CERTIFIED SURVEY MAP (CSM) & REZONING APPLICATION

5/9/22 Plan Commission Meeting

Village Planner Report

SUBJECT: Ceman CSM Review

CERTIFIED SURVEY MAP NO. _____

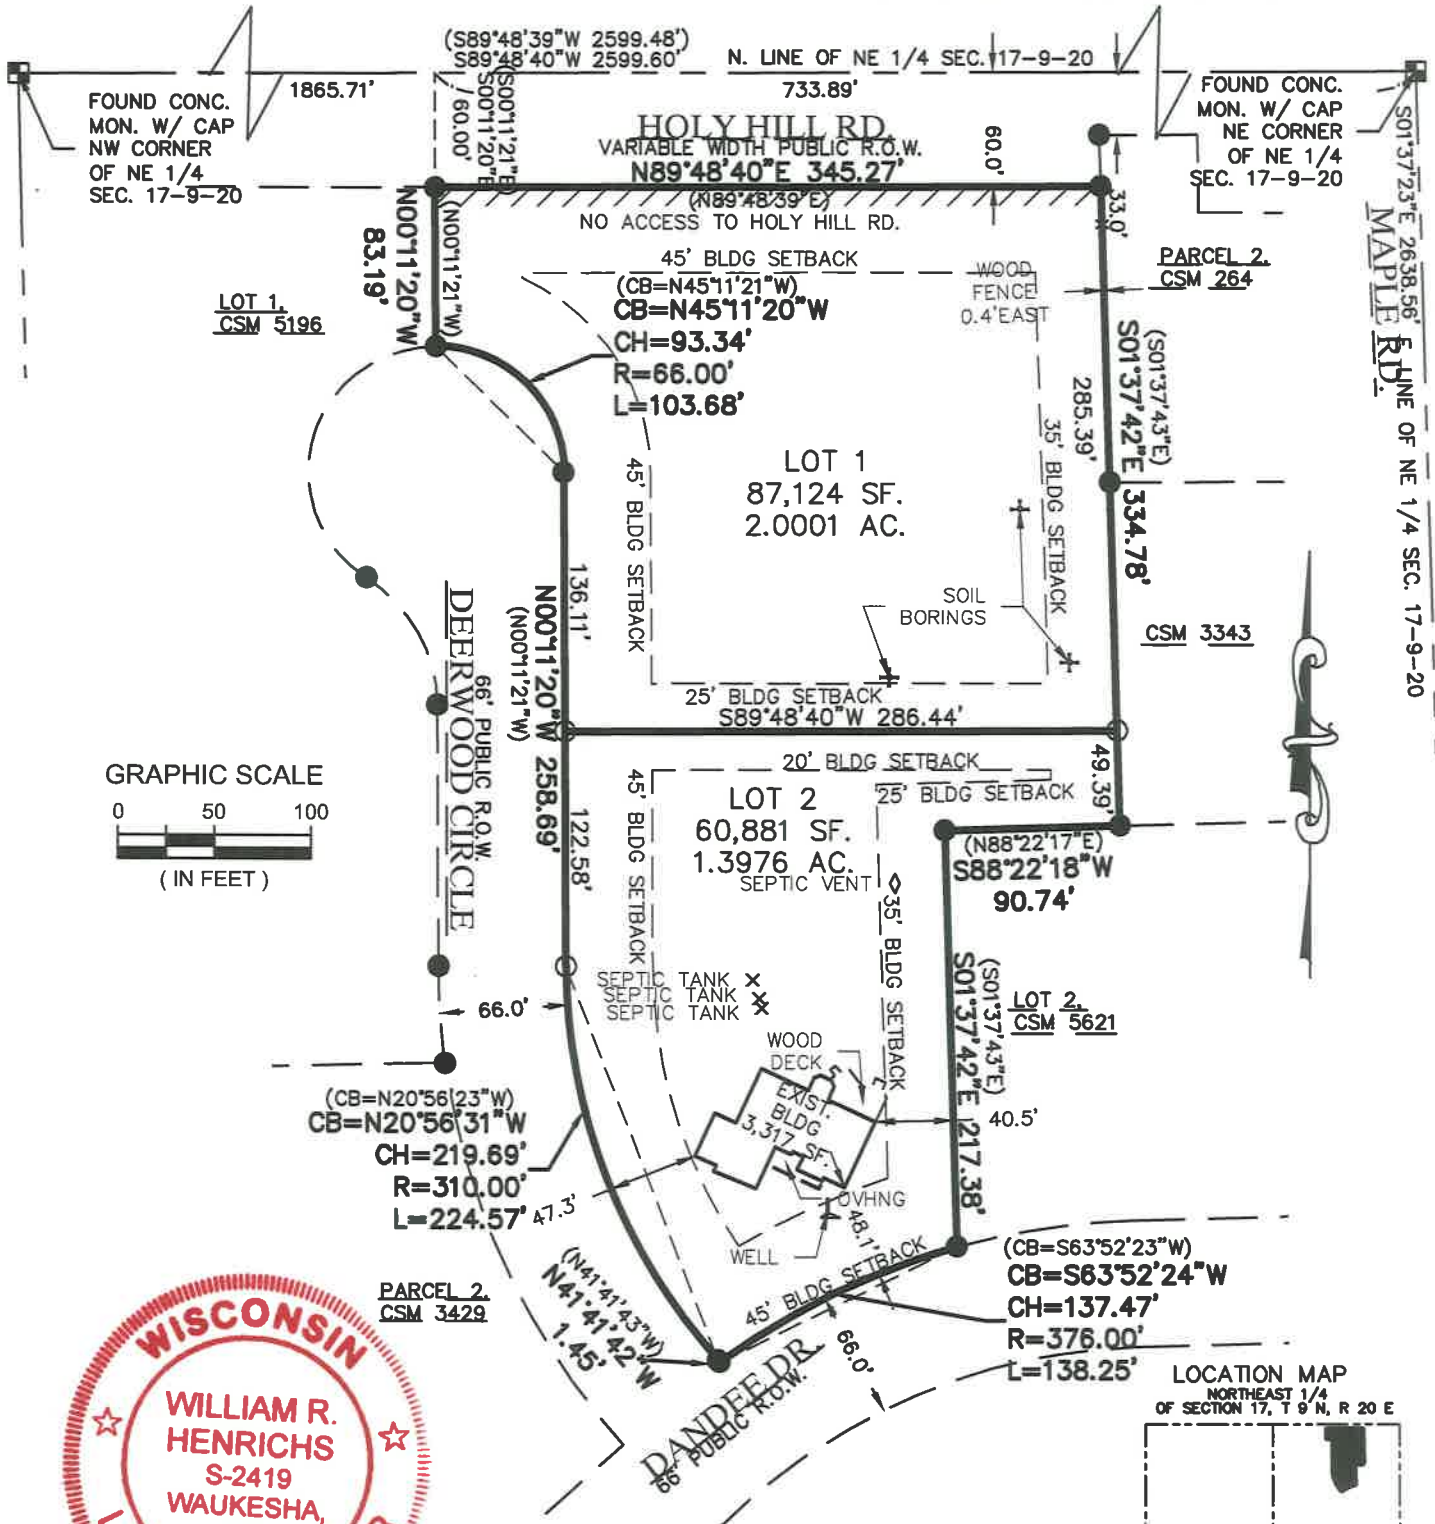
1. A 3" x 3" square in the upper right-hand corner is to be left blank for the County recording information.
2. Coordinates (NAD 1883 Grid) of point of commencement monument need to be labeled.
3. The Point of Beginning should be labeled.
4. Soil Boring results are to be included.
5. Surveyor's Certificate should state "That I have fully complied with the provisions of Chapter 236.34 of the Wisconsin Statutes and Chapter 18 of the Village of Germantown Subdivision Control Ordinance in surveying, dividing and mapping the same."
6. The Mortgage Certificate should not be referencing Eric R. Sturm as the Surveyor.
7. Modify "Planning Commission" to read "Plan Commission" in three locations on Sheet 5 of 5.
8. The Village of Germantown Board Approvals should show the Village Clerk as Deanna Braunschweig.

1. All technical issues and plan correction identified by the Village’s engineering consultant and Public Works Director in the memo dated April 15, 2022 shall be addressed and reflected in a revised CSM submitted and approved by the Village Engineer prior to recording the CSM.
